Final Environmental Impact Report on the

Natomas Levee Improvement Program
Phase 4a Landside Improvements Project

State Clearinghouse No. 2009032097

SUBJECT: **FINAL ENVIRONMENTAL IMPACT REPORT ON THE NATOMAS LEVEE IMPROVEMENT PROGRAM PHASE 4a LANDSIDE IMPROVEMENTS PROJECT (SCH # 2009032097)**

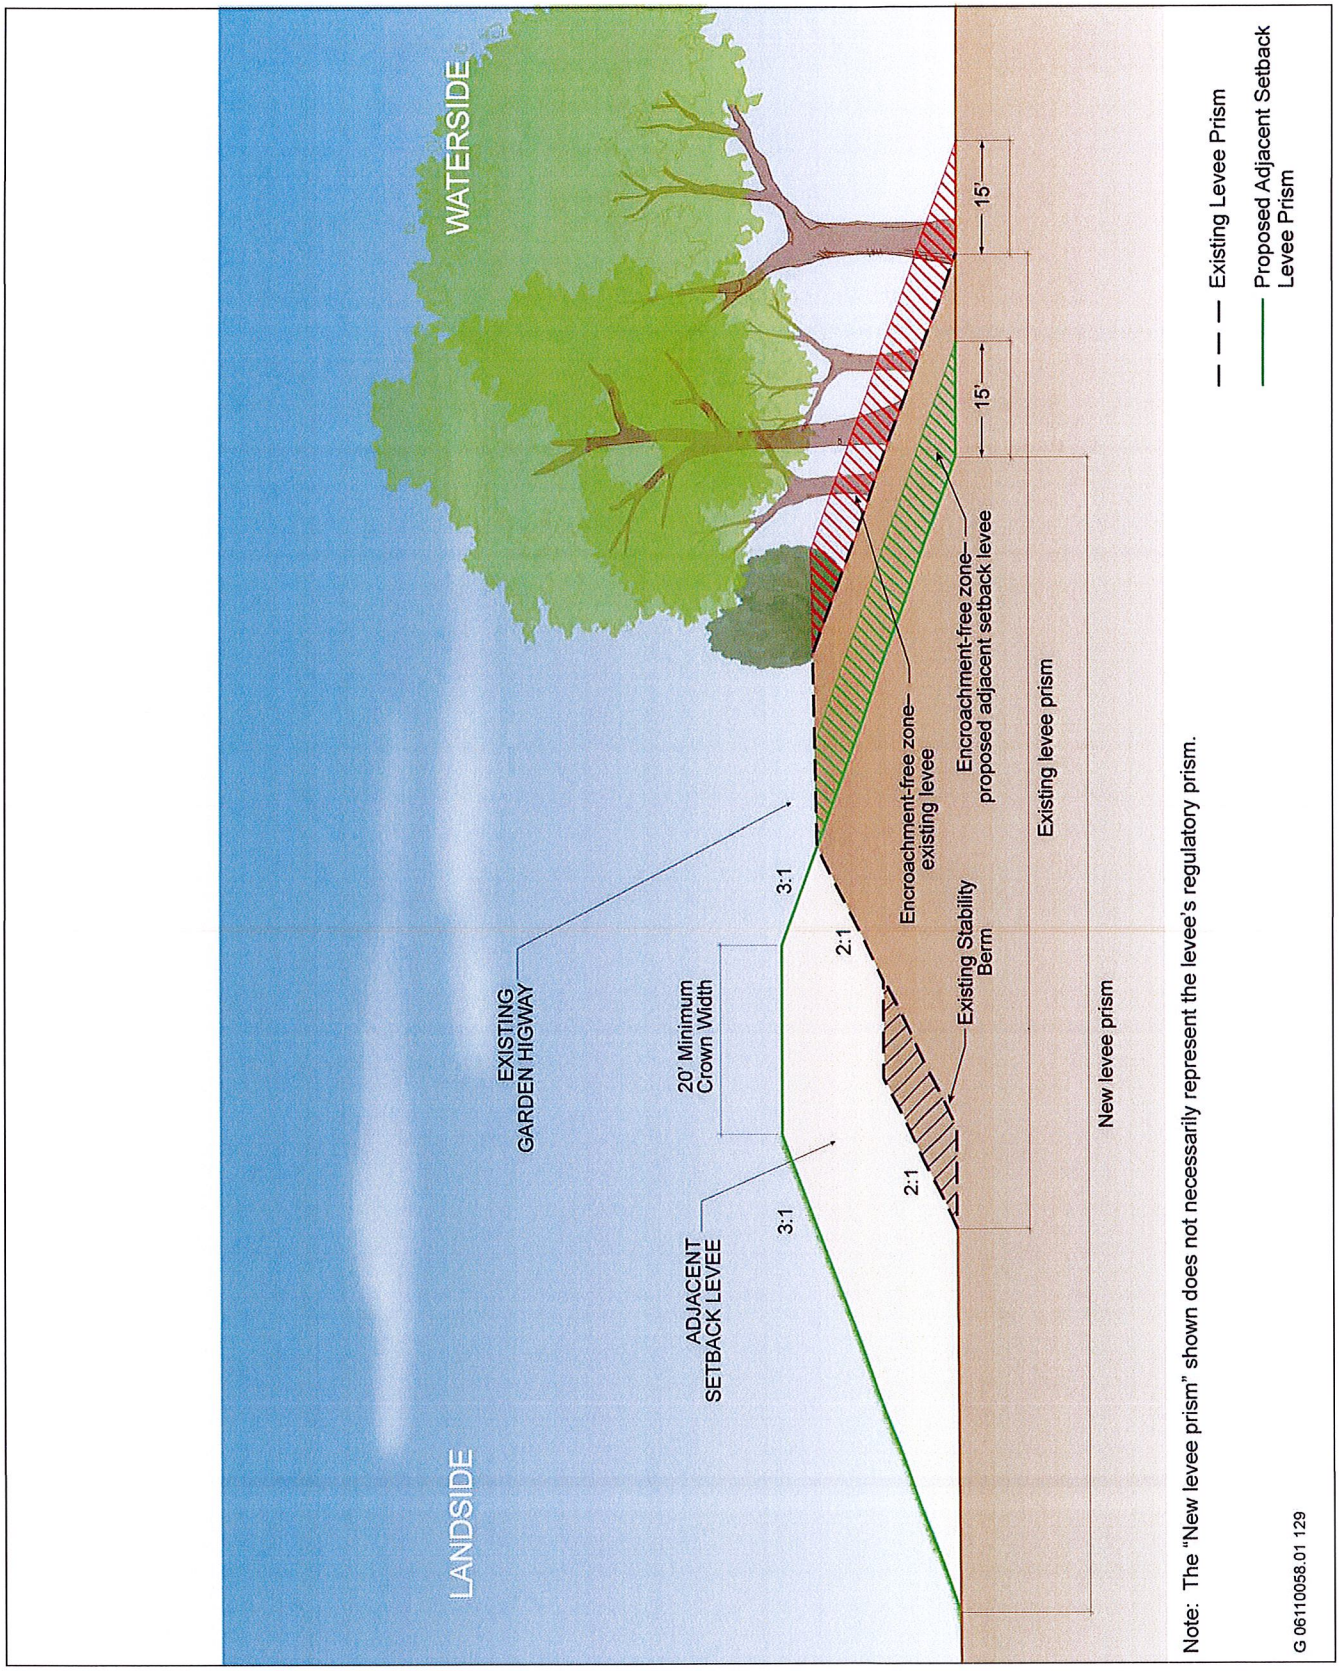
Plate 4 shows a typical profile view of the existing levee along the east side of the Sacramento River in comparison to the adjacent setback levee proposed for the Phase 3 Project (Reaches 5A–9B). The prism for the existing levee consists of:

N
W
E
S
2010330044
2010330041
2010280045
1.6 AC.
2010330043
9.3 AC.
2010330042
9.75 AC.
2250010047
2250010039
2250010045
2250010046
2250010042
2250010043
34.64 AC.
2250010038
24.26 AC.
2250010041
4.2 AC.
0
500
1,000
2,000 Feet
Siddiqui Properties
Figure 1

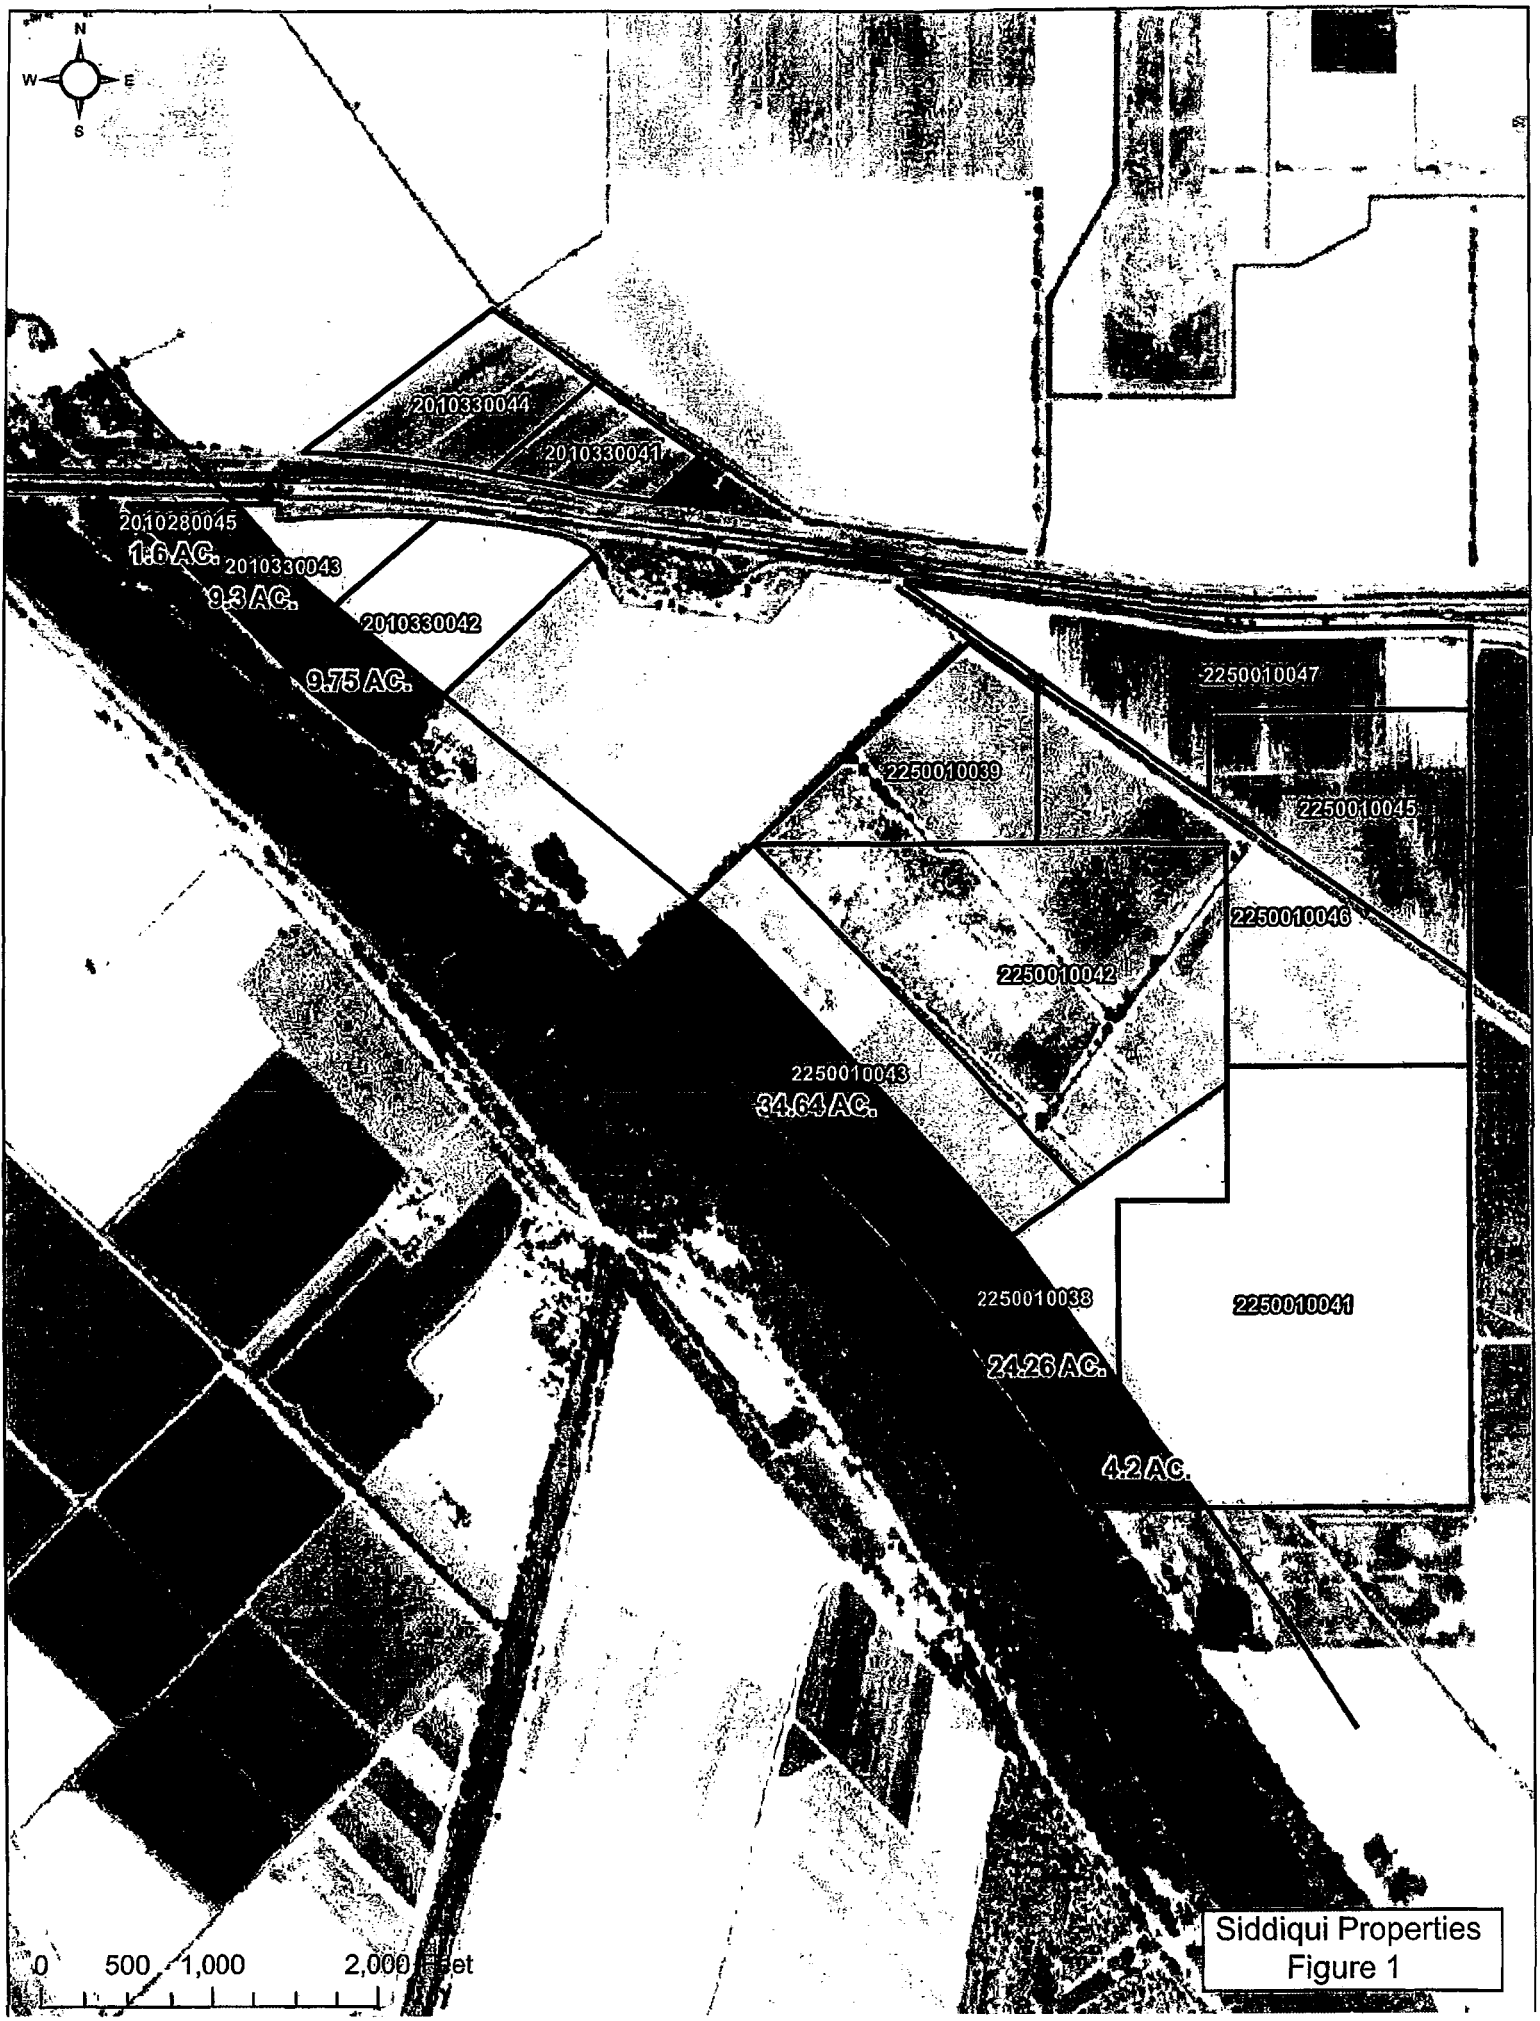
The following information summarizes SAFCA's Natomas Levee Improvement Program (NLIP) improvements along the Sacramento River east levee (SREL) and presents specific engineering data and analyses regarding the design of the NLIP improvements in the vicinity of the Siddiqui properties along the SREL between Interstate 5 and Powerline Road (see Figure 1).

As shown in Figure 1, the northern Siddiqui property along the SREL consists of Sacramento County Assessor's Parcel Numbers (APNs) 201-0280-045, 201-0330-042 and -043. The southern Siddiqui property consists of Sacramento County APNs 225-0010-038, -039, -041, -042, -043, -045, -046, and -047.

FIGURE
3

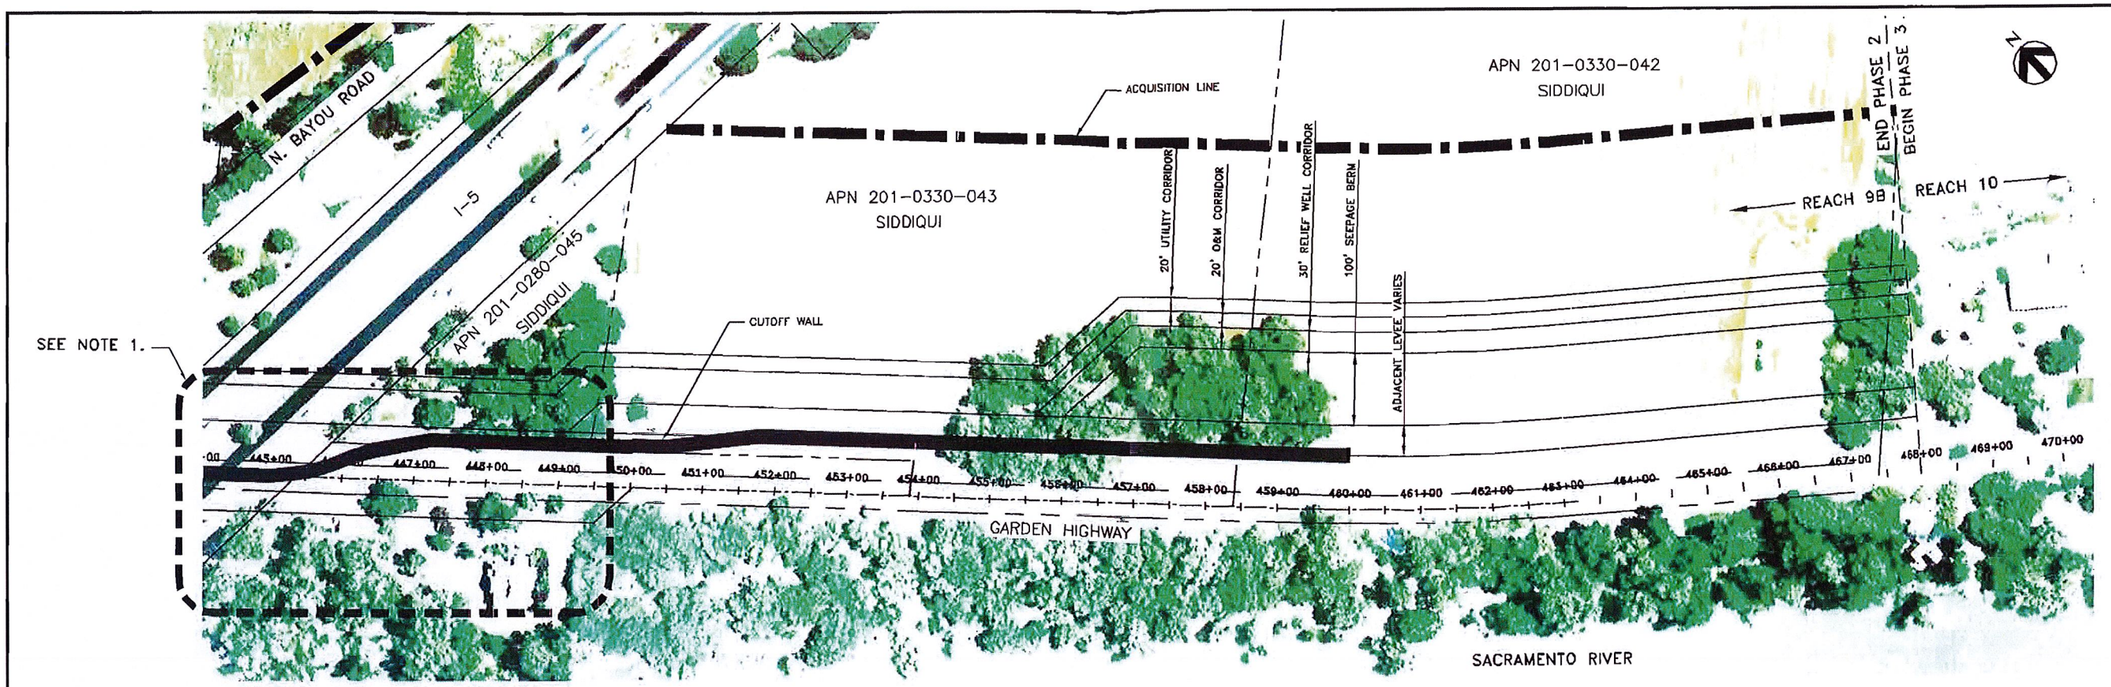
As shown in Figure 3, Alternative 3, the raised-adjacent-levee-with-cutoff-wall alternative, would result in a levee footprint approximately 126 feet wide as measured from the centerline of Garden Highway. The raised-adjacent-levee-with-cutoff-wall alternative was not preferred because the cutoff wall was determined to be infeasible due to high cost and the seismic vulnerability of this reach.
